Access Compliance Report Public Rights-of-Way (Curb Ramps)

Main Street: MEANDERING_TRAIL Cross Street: ANTONIO_PKWY Location: S

ADA ID: RPRK211018160726 Ramp Type: Type 4 - Parallel Initial Pass/Fail: Fail Overall Compliance: No Severity Score: 30

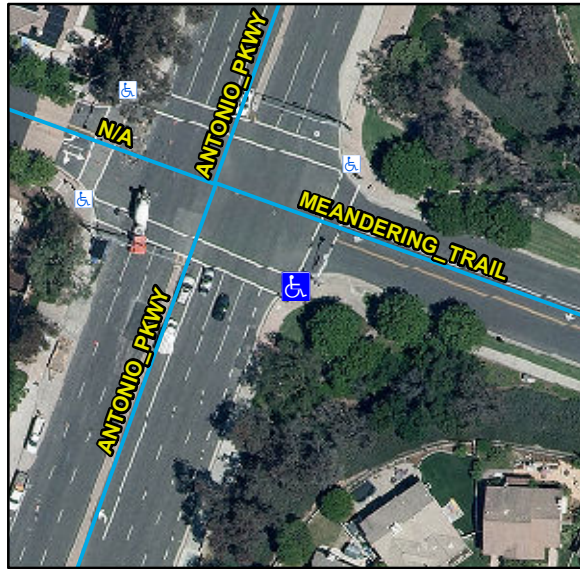
Compliance	Description	Data	Compliance	Description	Data
N/A	Ramp Length LT (in)	68	N/A	Ramp Length RT (in)	68
Yes	Ramp Width LT (in)	102	Yes	Ramp Width RT (in)	94
Yes	Ramp Run Slope LT (%)	6	Yes	Ramp Run Slope RT (%)	2.6
No	Ramp Cross Slope LT (%)	4.9	No	Ramp Cross Slope RT (%)	7.2
N/A	Landing Present	N/A	N/A	DWS Provided	N/A
N/A	Landing Length (in)	N/A	N/A	DWS Contrast	N/A
N/A	Landing Width (in)	N/A	N/A	DWS Length (in)	N/A
N/A	Landing Run Slope (%)	N/A	N/A	DWS Full Width	N/A
N/A	Landing Cross Slope (%)	N/A		DWS Offset Type	N/A
N/A	Landing Movement Obstructed?	N/A	N/A	DWS Offset Left (in)	N/A
	Landing Movement Type	N/A	N/A	DWS Offset Right (in)	N/A
N/A	Landing Shared	N/A			
N/A	Clear Space	Yes			
N/A	Clear Space To Crosswalk (in)	N/A			
N/A	Marked Crosswalk 1	No	N/A	Marked Crosswalk 2	No
	Crossing 1 Direction	NE		Crossing 2 Direction	NW
N/A	Marked Crosswalk 1 Width (in)	N/A		Marked Crosswalk 2 Width (in)	N/A

Remove & Replace Curb Ramp With Two New Directional Ramps or Equivalent.

R204.3, R304.5.3, STD 1115
